**Poolbeg Incinerator**

**EIS Climate Models**

**A Critique of the Poolbeg 3 Model**

**Joe McCarthy and Valerie Jennings**  
**August 2007**

### Capacity diagram

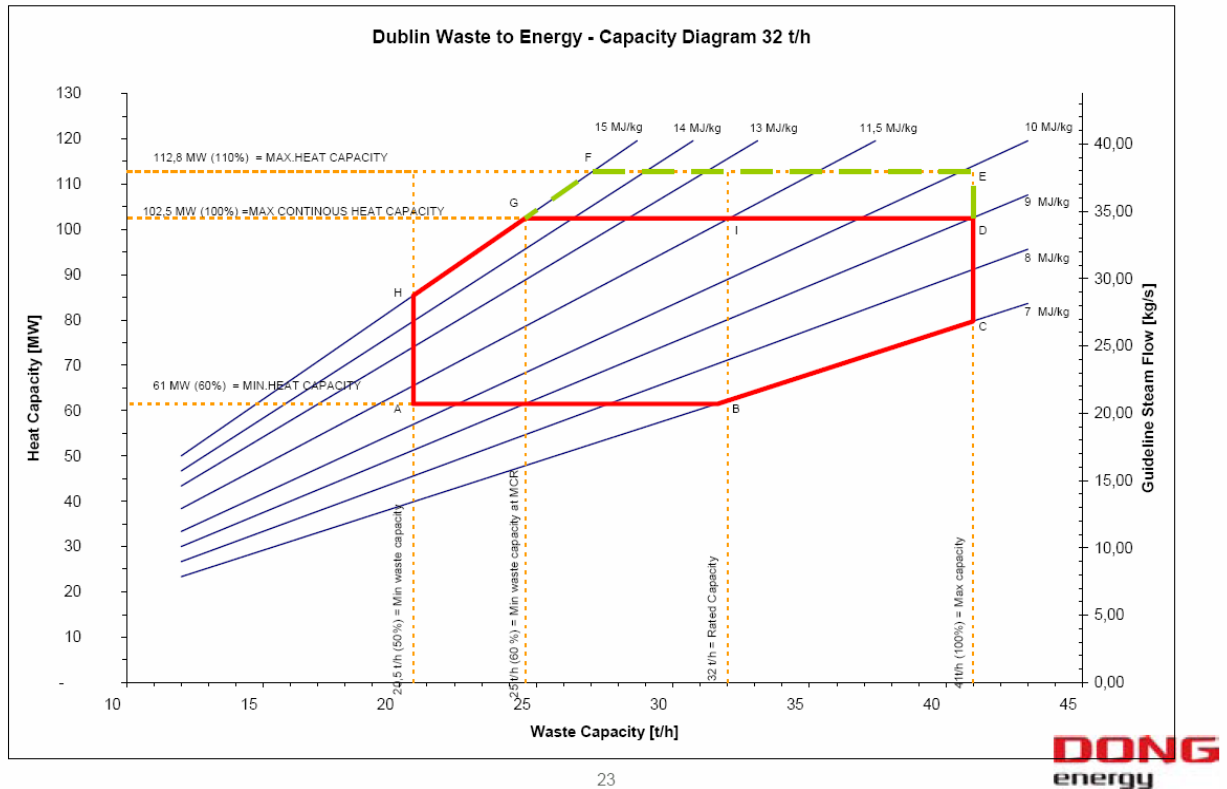
This assertion suggests that the furnace and the boiler would have to be sized even larger than the current design as described by Mr Norgaard. His current design is equal to the largest of such plants in Europe – the same size as the new incinerator in Line 6 in Vestforbraending.

This assertion is unbelievable. We would prefer to have these figures confirmed by the combustion design engineer which we presume would be Mr Norgaard.

We carefully examined the capacity diagram which was presented by Mr Norgaard and we quizzed him on the physical capacity of his design.

He confirmed that the capacity diagram shows the maximum heat out put of the boiler is 102.5 MW. There are 2 boilers in this plant and therefore 205 MW is the maximum heat available. When this is multiplied by an ambitious efficiency factor of 29% provided by Mr Norgaard the result is 59.45 MW of electricity generated at the turbine.

### Poolbeg 3 – Scenario 1

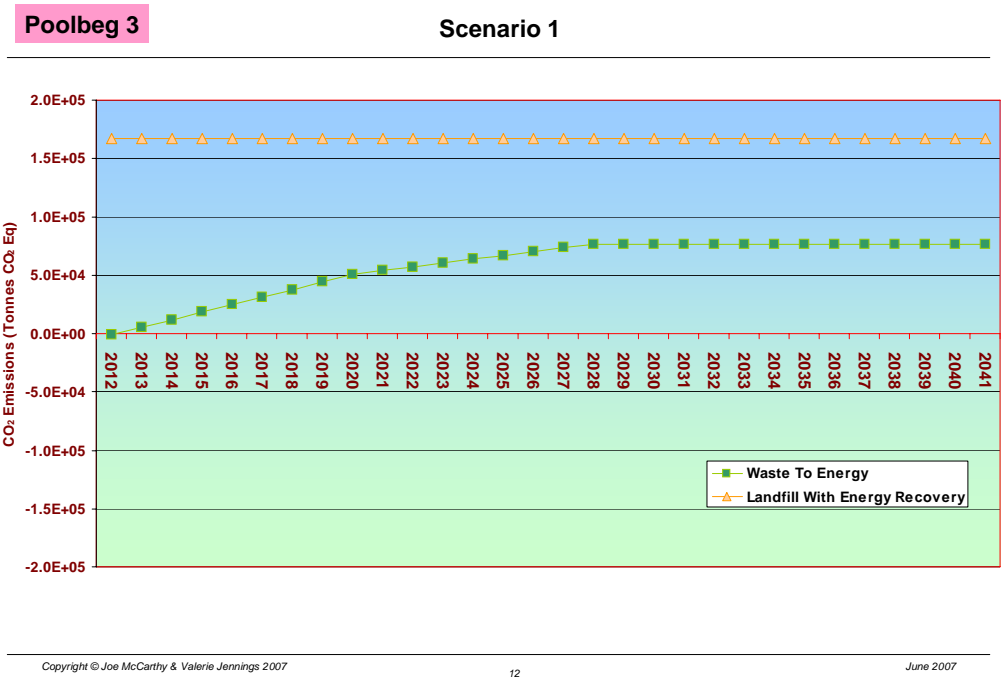
We were able to analyse just one graph because we had the graph for Scenario 1 – this is as published. It shows incineration on the green line as being just barely beneficial in 2012 and then becoming damaging over the period.

Landfill is shown without any calculation of the effects of carbon sequestration.

## Poolbeg 3 – Scenario 1 - Corrected

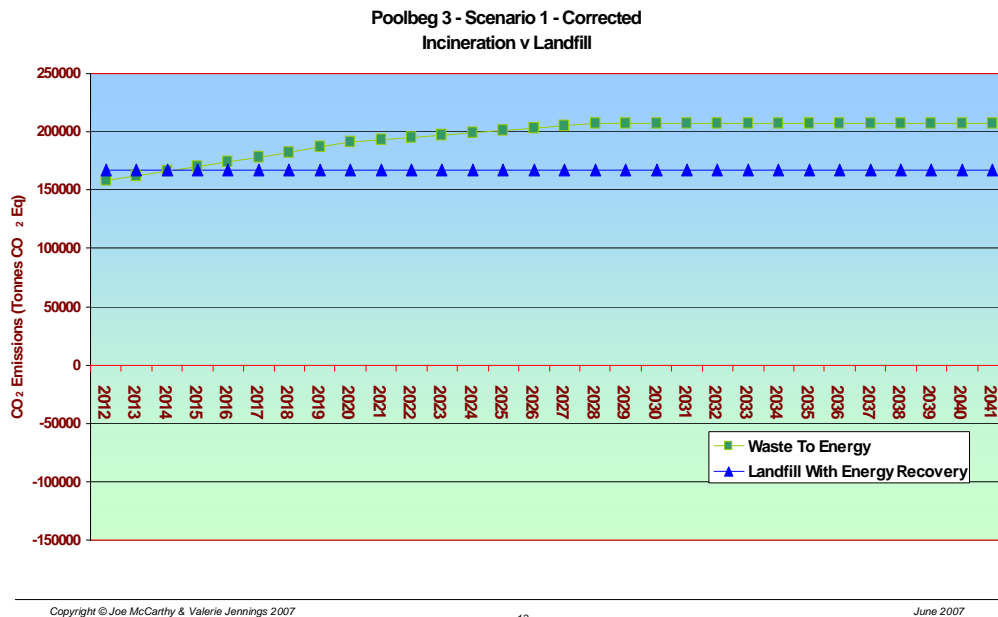
We recalculated Dr Porter's model with the corrections noted above and the difference in the green line for incineration line is significant.

Because Dr Porter omitted carbon sequestration in his Poolbeg 3 Model we were unable to run any comparison on this aspect.

This is a significant omission by him.
